UNITED STATES PATENT AND TRADEMARK OFFICE

APPLICATION NO.	FILING DATE	FIRST NAMED INVENTOR	ATTORNEY DOCKET NO.	CONFIRMATION NO.
09/864,389	05/25/2001	Jacob Richter	2390/49704	1194

Office Action Summary

A cell in Fig. 5, BERRY et al.

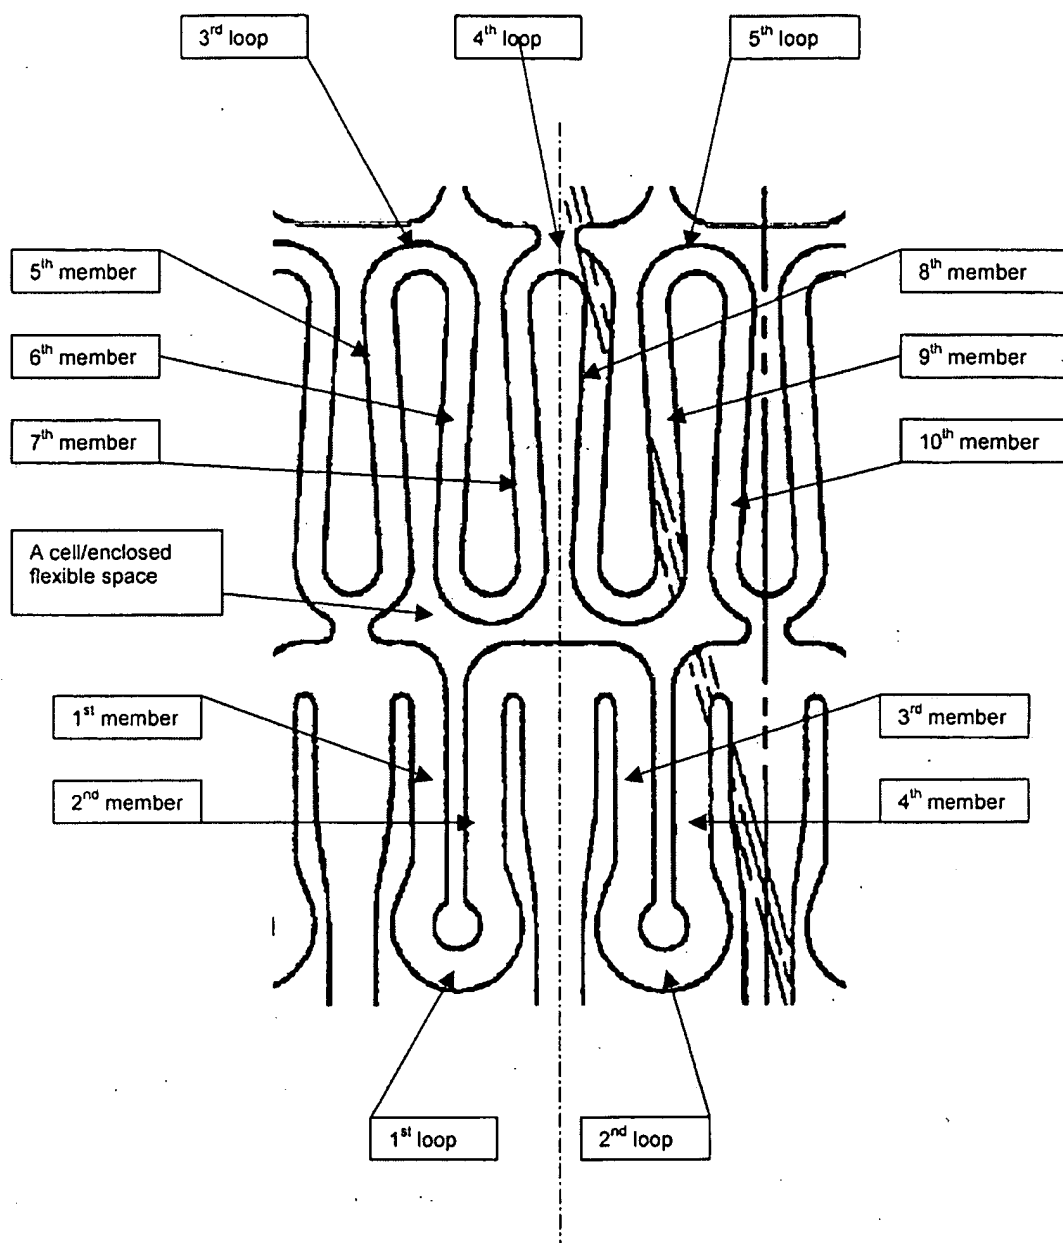
Berry-'598 discloses substantially all limitations recited in the claims, especially critical cells structured as recited in the body of the claim (see a portion of Berry-'598's Fig. 5 showing a cell reproduced on page 3 above) including wider members and narrower members of the cells, wherein the narrower elements are for flexibility and wider elements are for radial strength to support a blood vessel, except for Berry-'598 stent also includes other cells as indicated with dots in Fig. 5 (page 2 above). However, the cells as recited in the claim and as disclosed by Berry-'598 (as shown on page 4) are essential structures for the Berry-'598 stent as well as for the stent of the present invention. It would have been obvious to one of ordinary skill in the art to have other cell structures not important in combination with the cell structure as recited in the body of the claim, because the other cell structure is not as important as the structure recited in the body of the claim.

Fischell-6,190,403

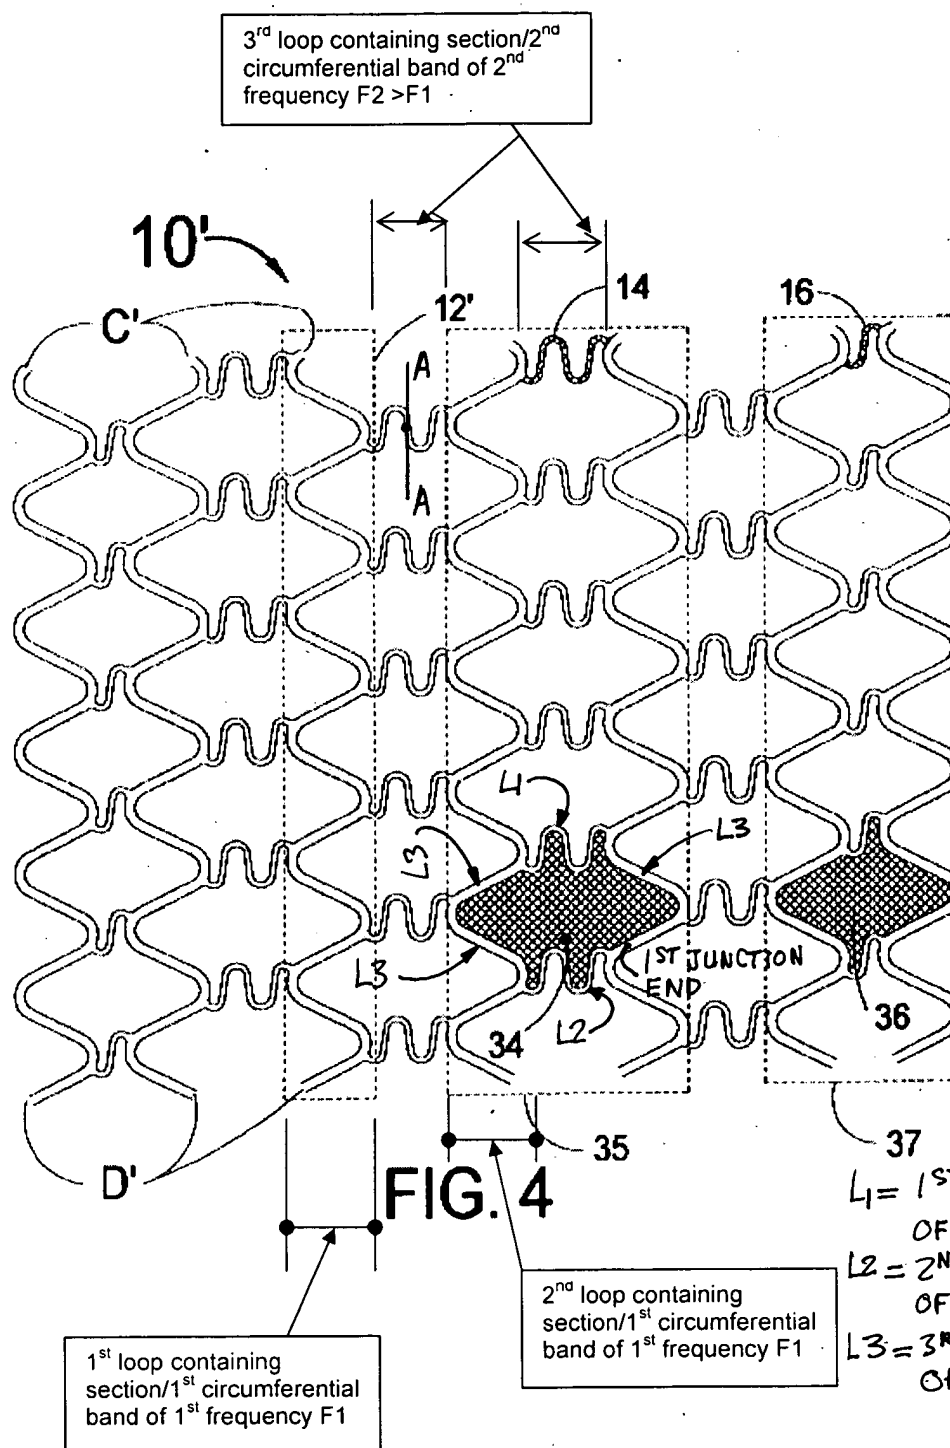
Please refer to Fischell'-403's Fig. 4 reproduced and shown in page 4 of this "Office Action".

1.1. As to claims 1, 6, 42-47 and 49, Fig. 4 shows 1st loop containing sections/1st circumferential bands of frequency F1, 2nd loop containing sections/1st circumferential bands of frequency F1, and elements 14 as 3rd loop containing sections/2nd circumferential bands of frequency F2 being higher than F1 ($F2 > F1$) extending in longitudinal, circumferential and radial directions of the stent 10' because they are 3-dimensional elements. Therefore, elements 14 indeed extend about a circumferential axis AA of stent 10' as recited in the claim.

Fig. 4 of Fischell'-403 clearly shows elements 14 having a width smaller than a width of 1st loop containing sections/1st circumferential bands of frequency F1 and 2nd loop containing sections/1st circumferential bands of frequency F1.

Further, Fig. 4 of Fischell-'403 clearly shows 1st loop containing sections of frequency F1 and 2nd loop containing sections of frequency F1 are out of phase 180 degrees.

1.2. As to claim 11, F. 4 of Fischell-'403 (see F. 4 reproduced above) show "triangular" cell 34 including elements 14 as 1st loop containing sections of frequency F1 and 2nd loop containing sections of frequency F1 define a 1st generally sinusoidal pattern, 3rd loop containing sections of frequency F2 ($F2 < F1$) defines a 2nd generally sinusoidal pattern and a first junction end (also an adjacent 3rd loop containing sections along the stent) as recited in the claim.

Notice that cell 34 can be considered as triangular because at least 3rd loop containing sections and first junction end have a triangular configuration.

Further, loops in one 3rd loop containing sections of 2nd sinusoidal pattern are 180-degree out of phase with the adjacent second sinusoidal pattern along the stent.

Response: element 14 as shown in Fig. 4 of Fischell-'403 is clearly qualified for the limitation "single, continuous, generally sinusoidal pattern" in the claims of the present invention. In general, a sinusoidal pattern only requires a pattern looks like a sine wave (see one page of attachment from www.merriamwebster.com).
